**Section 38 Agreement Works,
Land South of Rowley Lane,
Fenay Bridge, Huddersfield**

Stage I Road Safety Audit

April 2025

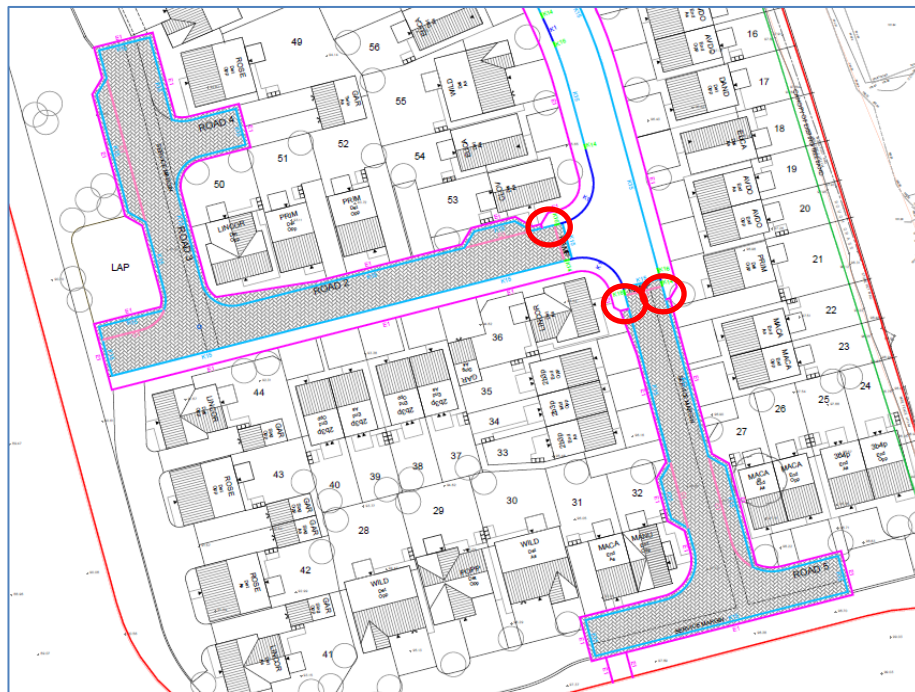
Location: Footways on Road 1 and Road 2 at transition from conventional street with footways on both sides to shared surface treatment

Summary: Risk of pedestrian trip/fall injuries due to lack of suitable connection between footway and carriageway

At the transition from conventional street with footways on both sides to shared surface treatment, it is assumed that the intention is for pedestrians to continue their journeys on carriageway. However, there appears to be a 30mm bull nosed kerb proposed at the footway/shared surface interface. A kerb with even a reasonably small upstand could increase the risk of pedestrian/trip fall injuries and may physically prevent those in wheelchairs/mobility scooters from accessing the shared surface area.

It is recommended that a suitable flush transition between conventional footway and shared surface areas is provided.
